Ashique Dress Design Ltd Ashique Jeans Apparels Ltd Nice Apparels Ind. Ltd.

43 Chalabon, Ashique Complex, Azampur, Uttara, Dhaka
(23.86794, 90.41752)

30th March 2014

Observations

Tested Ground Floor Columns

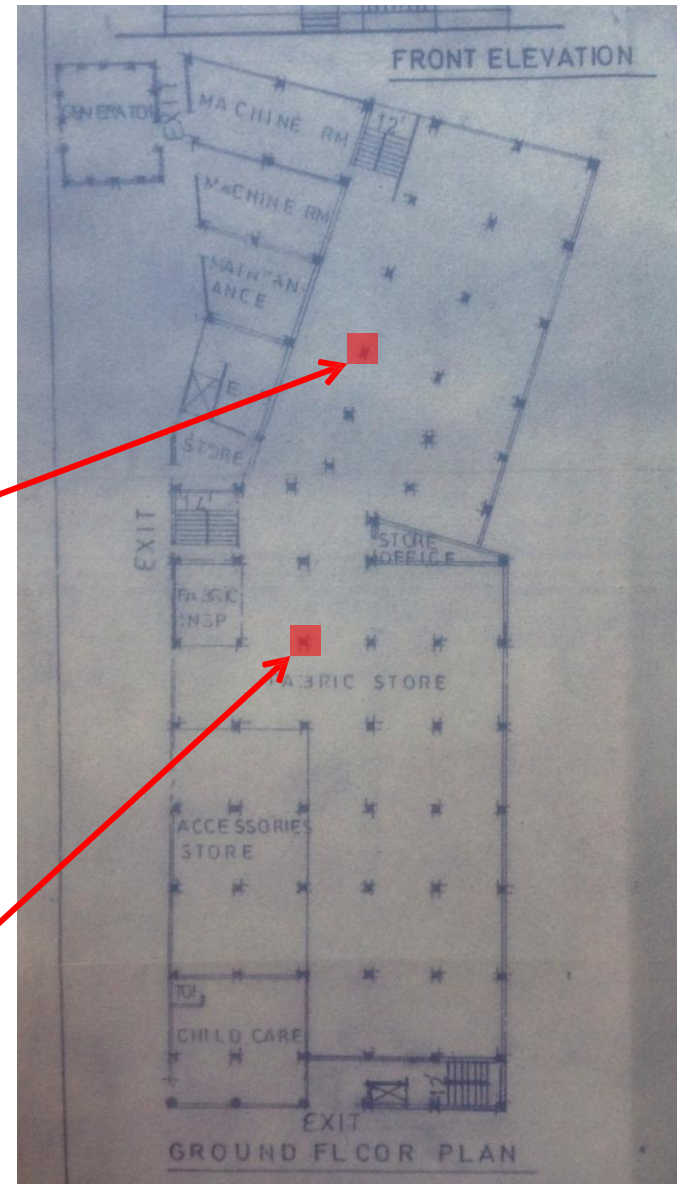
**Columns appear to be stressed to levels that
require immediate action**

Outline calculations indicate that the working stress of columns at Ground Floor level are at levels that require immediate action. Refer to Action 1.

Column Impact Loading

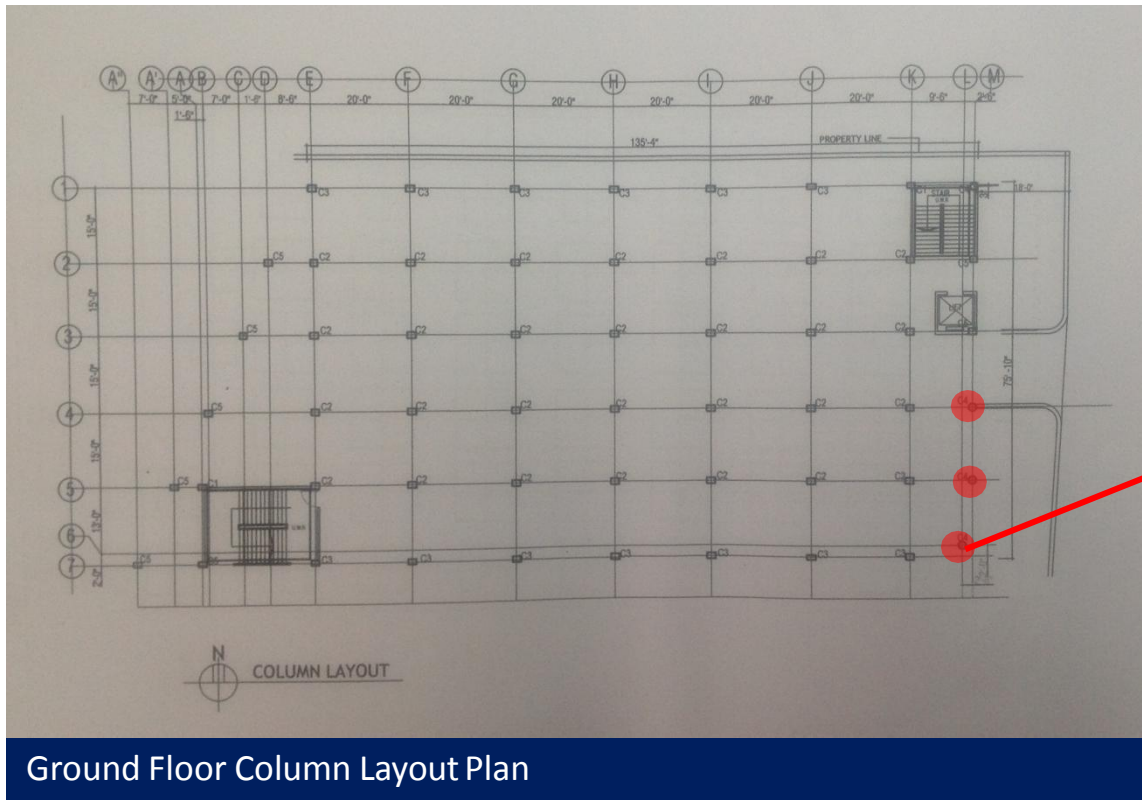
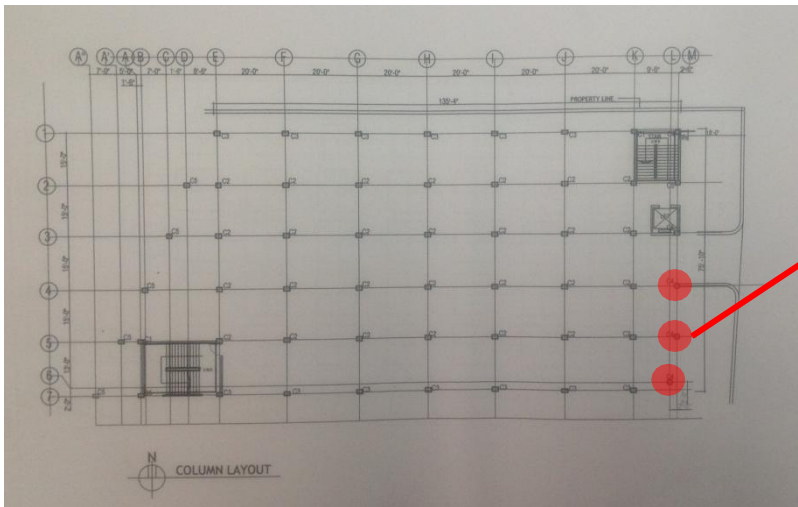
The feature columns adjacent to the entrance and car parking area are at risk of being accidentally struck by a vehicle. The robustness of the connection of these columns to the main structure also needs investigation

3 no. two-storey columns to the Main East elevation of the building, adjacent to the delivery entrance, are at risk of being accidentally struck by a vehicle. Column protection barriers need to be provided. Also Building Engineer to investigate the robustness of the connection of these columns to the main structure.

Column Connection Detail Unclear

Ten Storey Building – Typical Plan

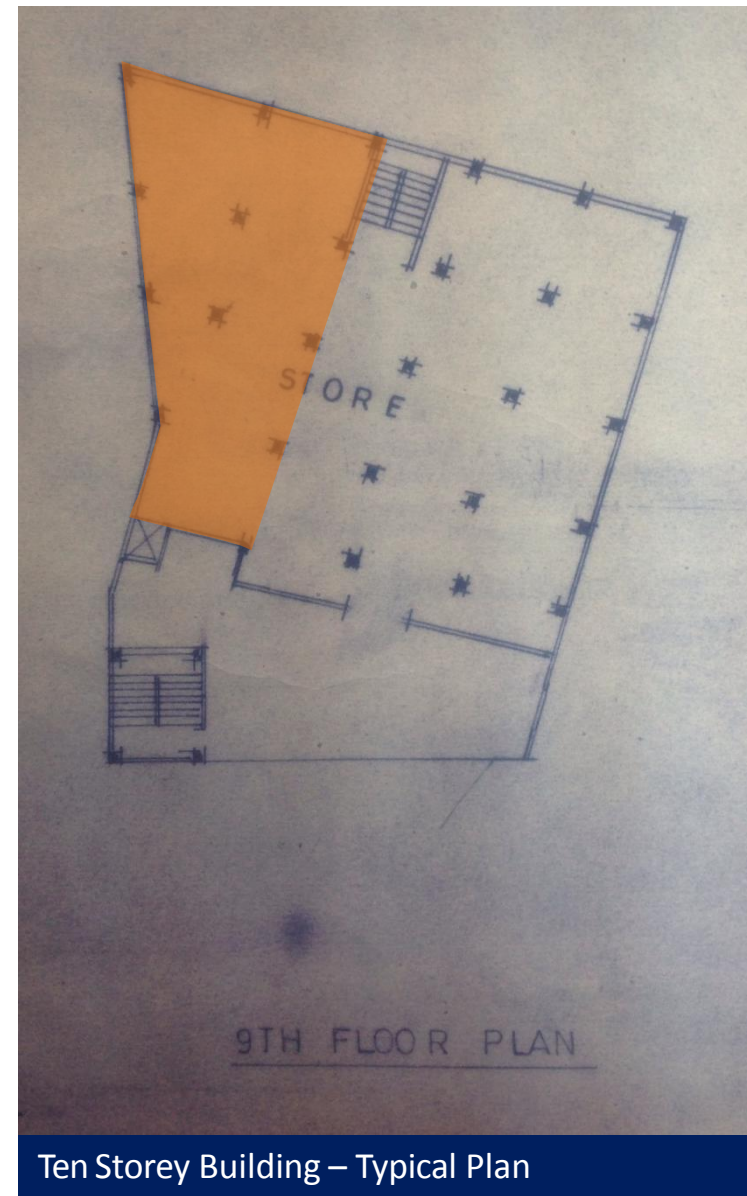
**Design Check required for the storage areas,
particularly to the South-West corner of the
building, to confirm the capacity of the floor
structure**

There are large amounts of storage in the Ten Storey building, particularly in the South-West Corner, as indicated.

Building Engineer to check that the beams and slabs have been adequately designed to carry the associated loading.

Typical Floor Plan

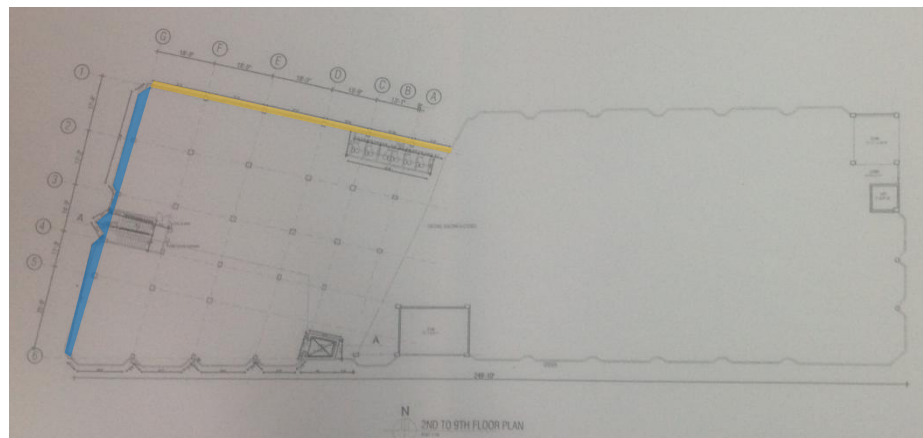
Design check required for the floor cantilevers at the suspended floor levels to confirm their load capacity to support floor and façade loading

In the ten storey building, the slabs cantilever from First Floor level up on the East elevation, and from Seventh Floor level to the North elevation. There are no downstand beams supporting the cantilevering slab. Building Engineer to check that all the floor cantilevers at the suspended floor levels have the capacity to support the floor and façade loading.

Ancillary Buildings Steel Roofs

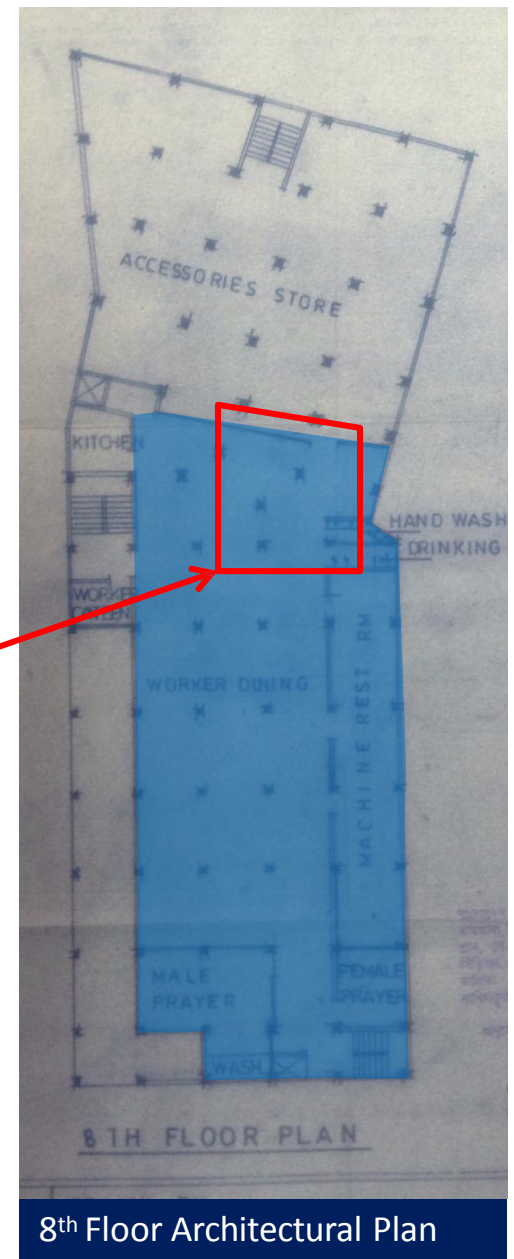
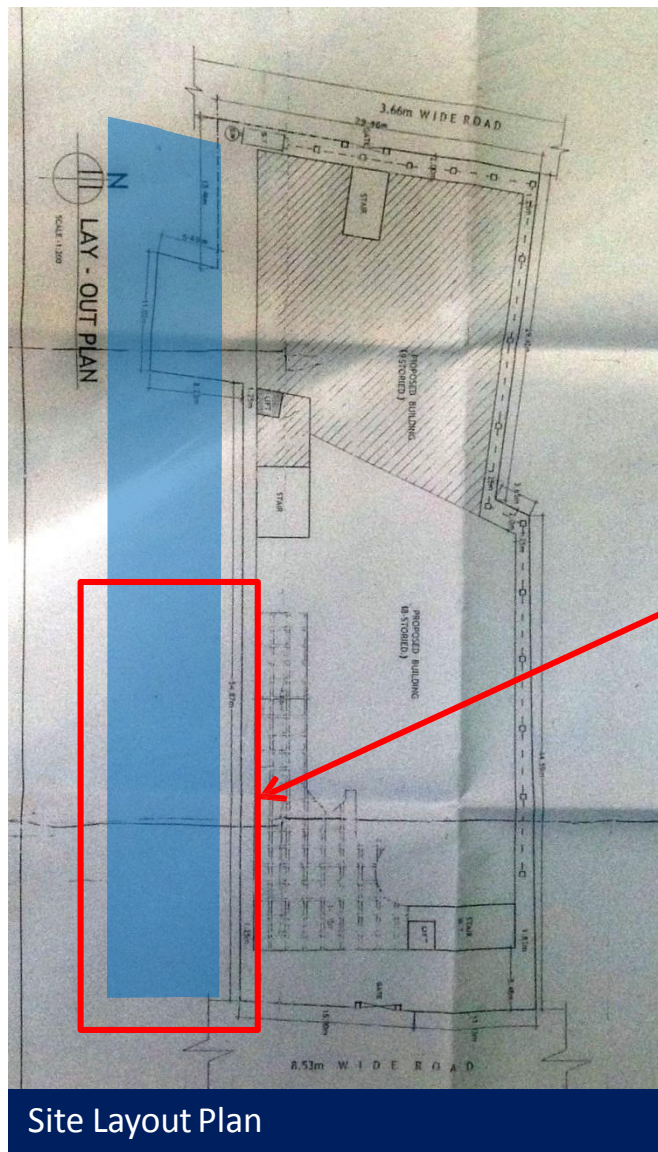
Design Check required for the light-weight steel roof structures to the 9-storey building dining area and the ancillary buildings, as indicated

A design check is required for the light-weight steel roof structures to the nine-storey building dining area and to the ancillary buildings to the South of the Main Building to confirm that they are adequate to resist wind loading. Particular emphasis is required on a section of the steel roof above the dining area which appears unstable. Building Engineer to implement any upgrade works to these structures as required.

Cracking to Floor Slab

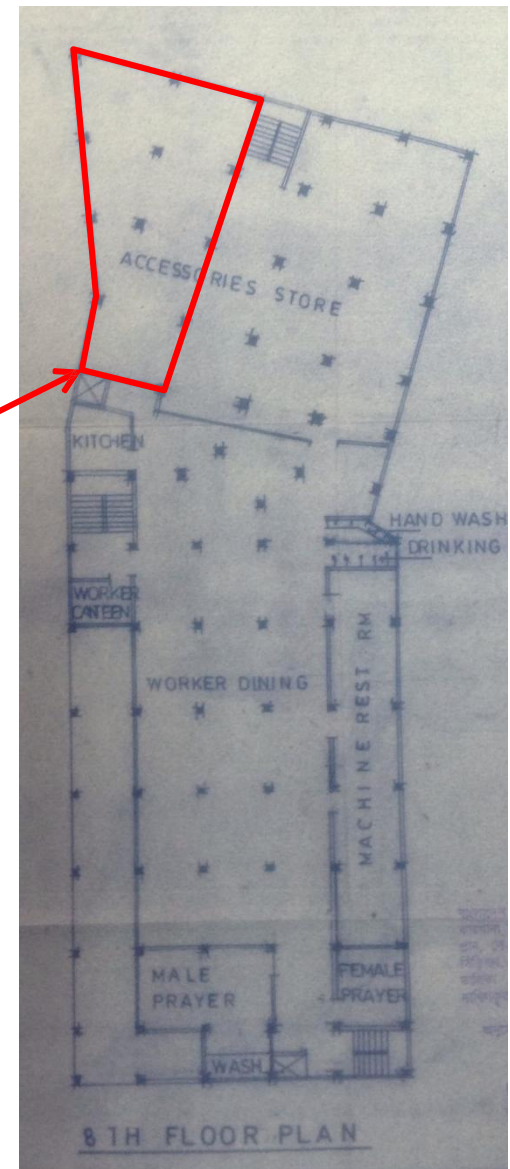
Building Engineer to investigate the cause of the local cracking to the 8th floor level slab in the South-West corner and to areas of the façade

There is evidence of local cracking to the Eighth Floor slab in the South-West corner of the building.

Building Engineer to investigate and carry out remedial works to the structure as required.

Cracking to Facade

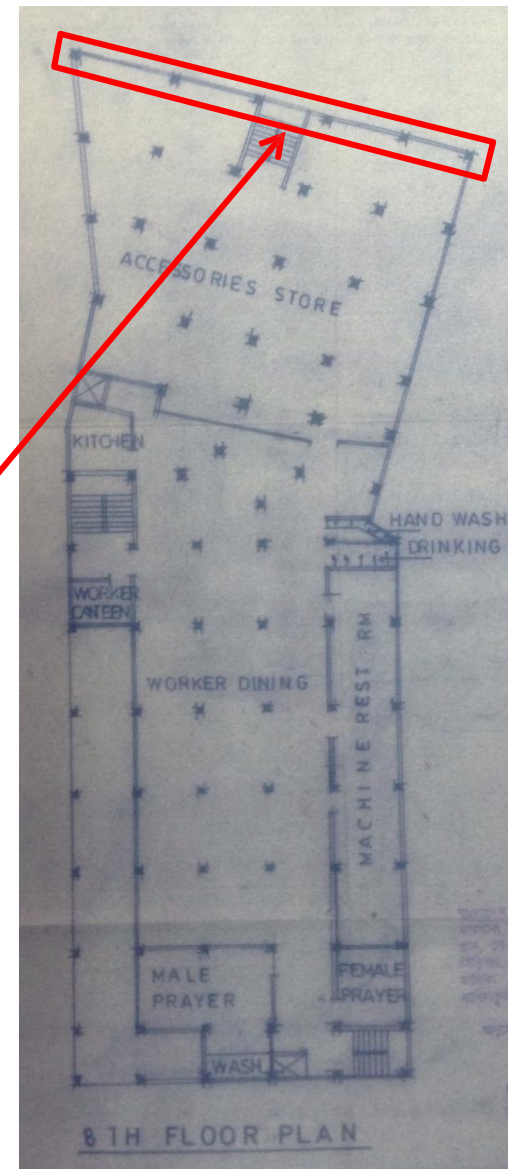
There is evidence of local cracking to the façade to the East Elevation of the building.

Building Engineer to investigate and carry out remedial works to the façade as required.

Permit Inconsistencies

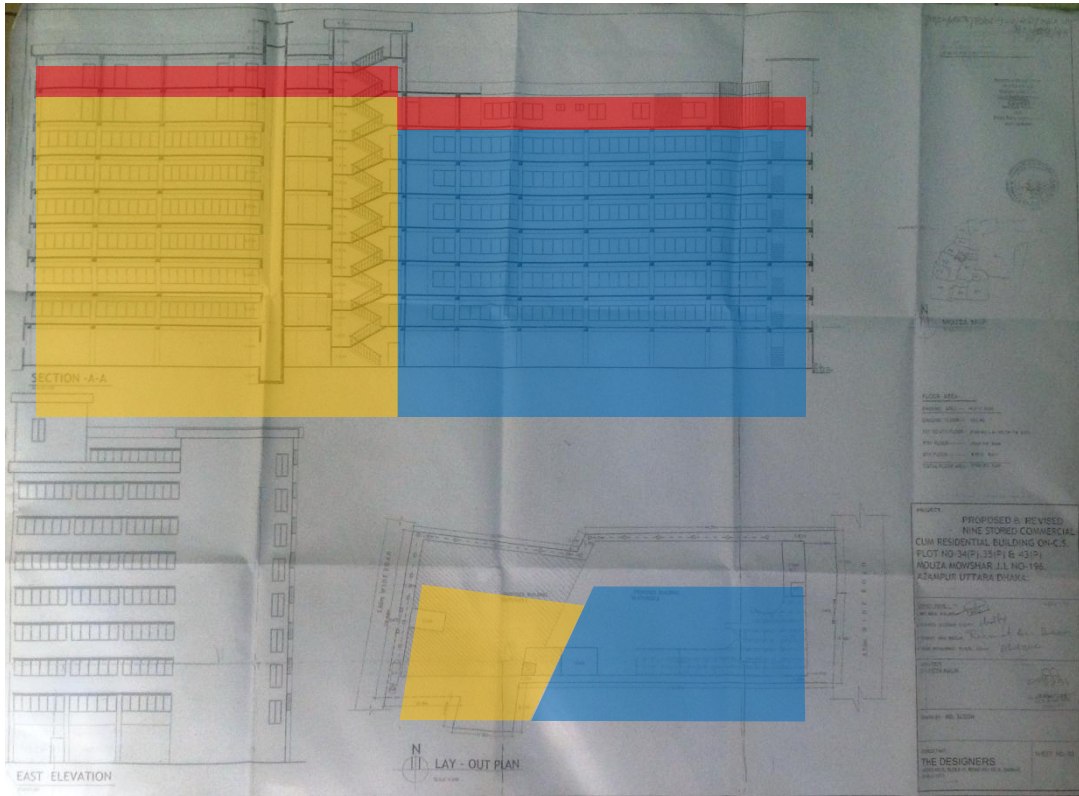
Inconsistencies in the Permit and Structural drawings presented

There are inconsistencies between the original building permit and the built structure. An additional floor has been included on each structure - the main build consists of a ten-storey building (1999-2004) and a nine-storey building (1998-2001), whereas the original Rajuk-approved building permit (1999) calls up a nine-storey building and an eight-storey building, respectively. Building Engineer to clarify.

Drawing Inconsistencies

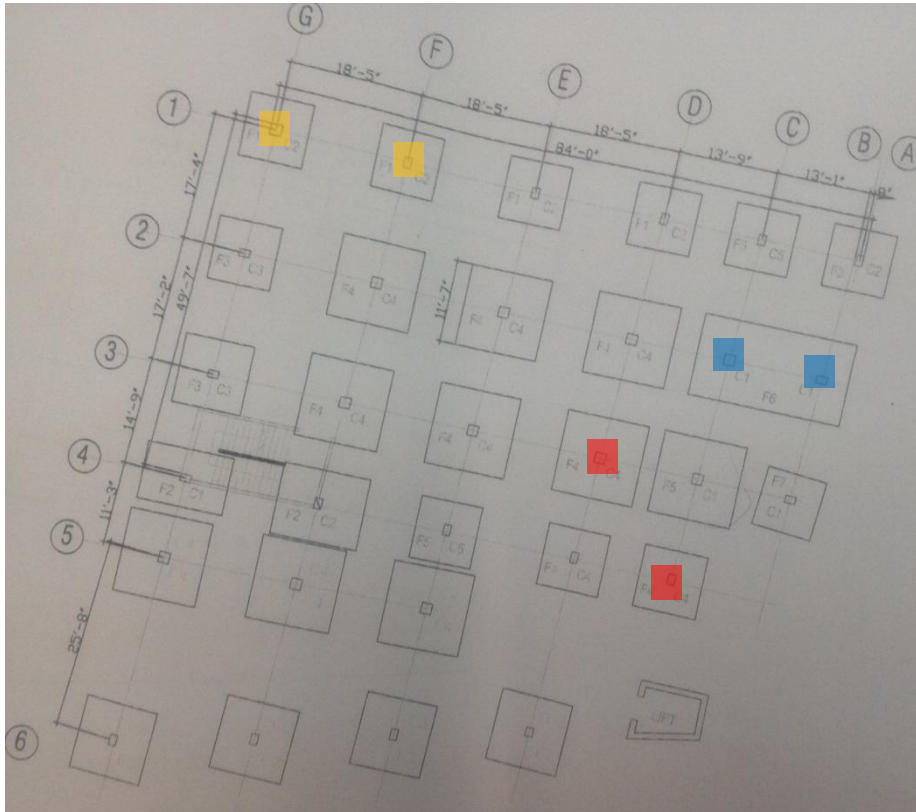
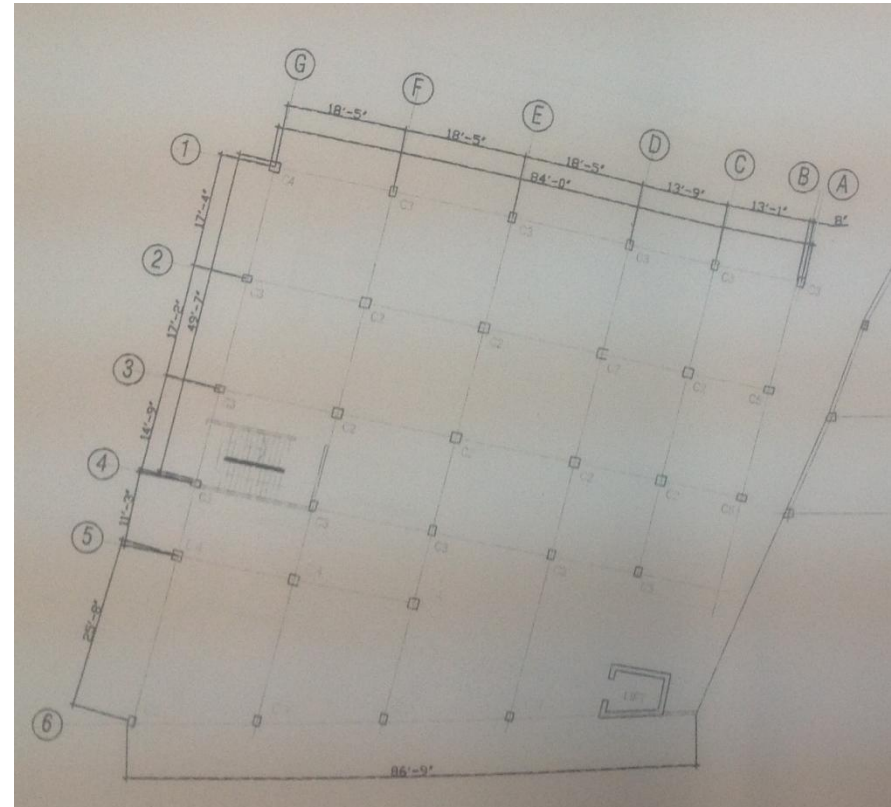
The structural drawings do not match the current arrangement of the building, and there are inaccuracies in the drawings. Building engineer to check, collect information and produce accurate and complete as-built documentation.

Inaccuracy in 10-storey building drawings:
The shape of the C1 (blue), C2 (yellow) and C4 (red) columns are shown up as both square and rectangular in the structural drawings, as indicated.

Inaccuracy in 10-storey building drawings:
The column sizes shown on the Footing Layout Drawing (left) and the Column Layout Drawing (right) do not match.

Inconsistency in column rebar for 8-storey building:
Drawings call up 16 no. bars in the C2 columns, whereas observed columns appear to have 12 no. bars (Ferroscanner).

Inconsistency in 10-storey building drawings:
The C5 column is called up as a square column (18" x 18") but is drawn as a rectangular column.
